U. S. NUCLEAR REGULATORY COMMISSION  
OFFICE OF INSPECTION AND ENFORCEMENT

Report No. 50-508/83-05  
Docket No. 50-508 License No. CPPR-154 Safeguards Group \_\_\_\_\_

Facility Name: WNP-3

SUMMARY: Inspection during the period of March 28 - April 27, 1983  
(Report No. 50-508/83-05)

Figure 8 - Arrows point to metal protecting shields for half-round pipes which compose the subsurface vertical drains of the Ground Water Drainage System.

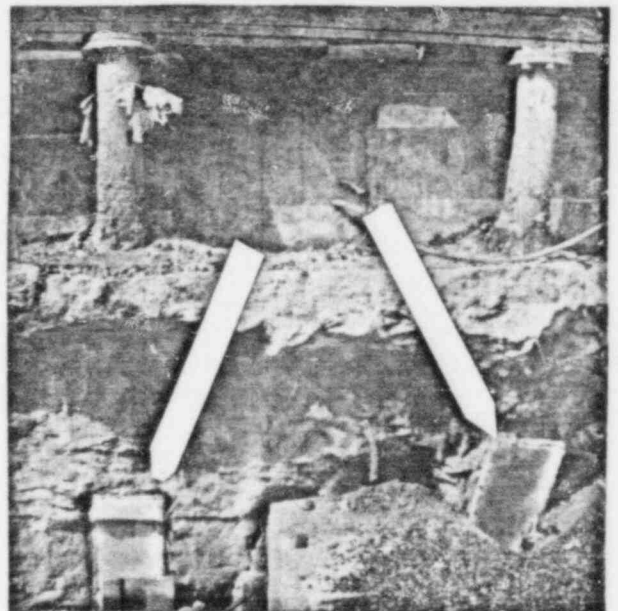
- a. LER 82-074/034-1 at Beaver Valley was found to be not applicable to WNP-3 since the same brand of check valves are not used in the charging pump outlet lines.
- b. Figure 8 shows protection provided for the half round pipes of the Ground Water Drainage System after NRC inspectors noted problems with dirt entering this system from non-safety-related work.
